This record drawing is a compilation of the sealed engineering drawing for this project, modified by addenda, change orders and information furnished by the contractor. The information shown on the record drawings that was provided by the contractor or others not associated with the design engineer cannot be verified for accuracy or completeness. This original sealed drawings are on file at the offices of Birkhoff, Hendricks & Conway, L.L.P.
BY RVC DATE 5/12/09

CITY OF ROCKWALL, TEXAS
NEIGHBORHOOD DRAINAGE IMPROVEMENTS
DRAINAGE SITE 5 IMPROVEMENTS
HEATH STREET WEST OF FANNIN STREET

SHEET NO.
13

PLAN CLARIFICATION NO. 2 MAY 23, 2007
PLAN CLARIFICATION NO. 1 APRIL 26, 2007

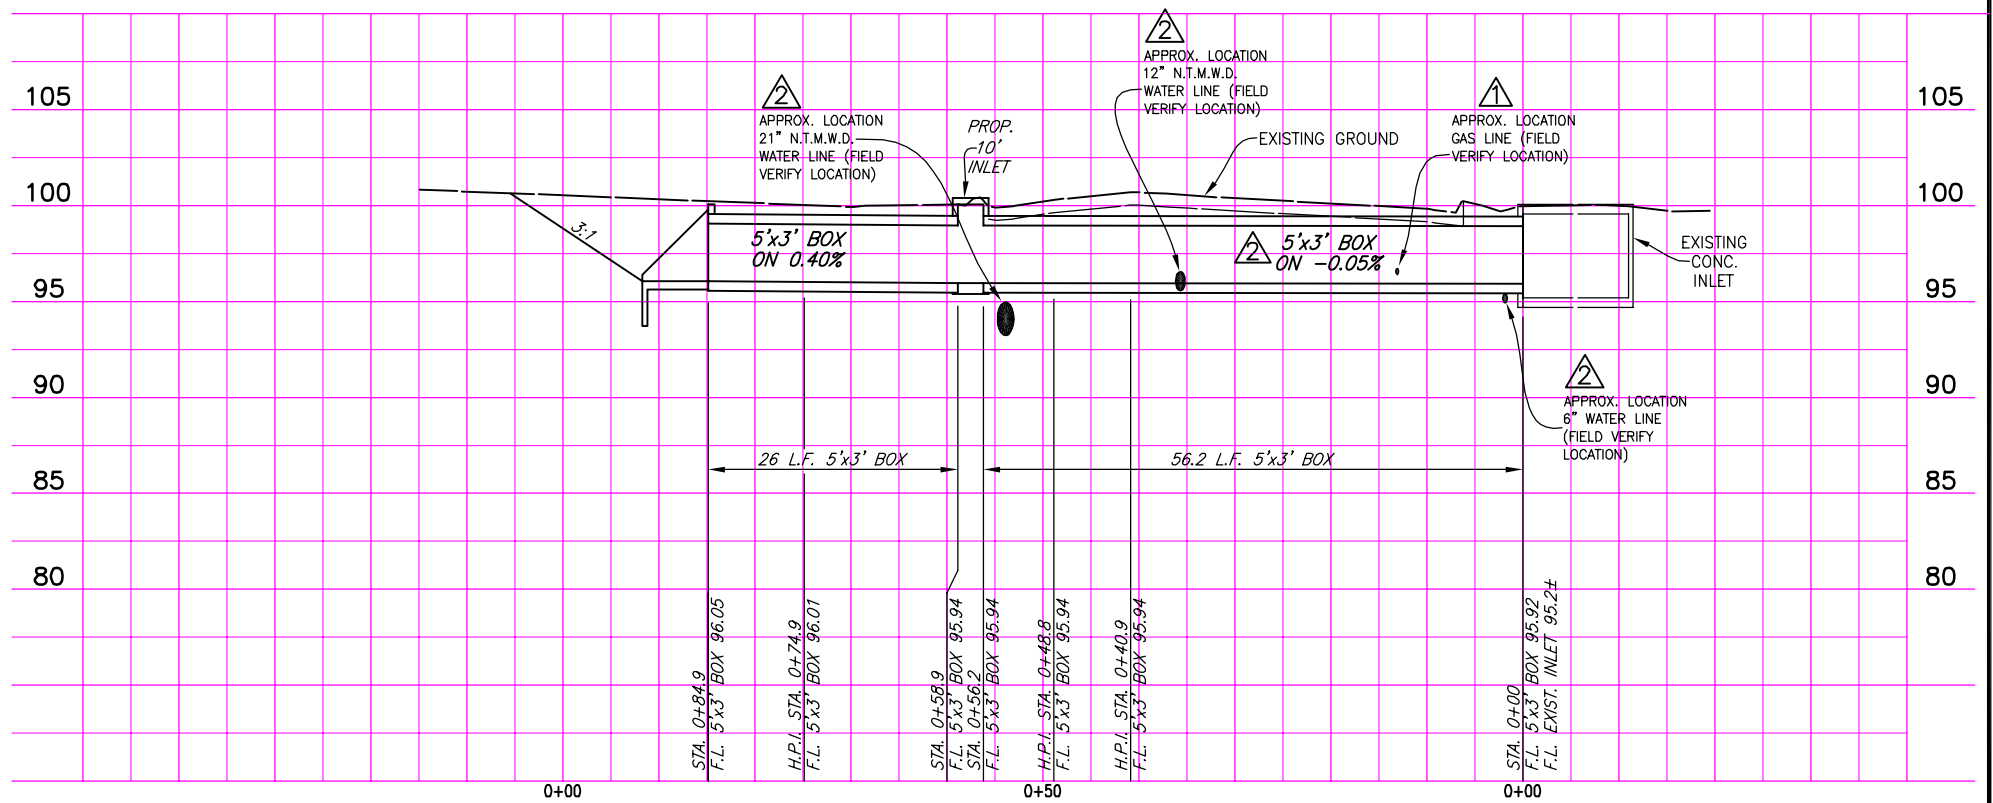
LOWER EXISTING 12" WATER LINE AND CONSTRUCT 6" BLOW OFF WITH 6" VALVE, 12"x6" TEE AND 6" 45' BEND. BLOW OFF PIPE SHALL DISCHARGE INSIDE THE PROPOSED BOX STORM SEWER AND END WITH A 6" FLAP VALVE.

REMOVE EXISTING INLET. CONSTRUCT 10' CURB INLET. ADJUST LOCATION OF INLET AS NECESSARY TO AVOID CONFLICT WITH EXISTING BLOW OFF PIPE. CUT EXISTING 6" BLOW OFF PIPE, INSTALL NEW RESTRAINED 6" 90' BEND, 6" DIP AND 6" FLAP VALVE TO RELOCATED 6" BLOW OFF INTO NEW STORM WATER INLET.

NOTE:
CONTRACTOR SHALL REMOVE TWO EXISTING 32' LONG JOINTS OF 12" RCCP AND LOWER 12" WATER LINE USING 12" MOTOR COATED (AWWA C104) DUCTILE IRON PIPE (AWWA C-151, CLASS 51) WITH RESTRAINED (MEGALUG) 45' FITTINGS. PIPE AND FITTINGS SHALL BE POLY WRAPPED (AWWA C105). EXPOSED STEEL SURFACES ON THE EXISTING 12" RCCP SHALL BE CEMENT MORTAR COATED.
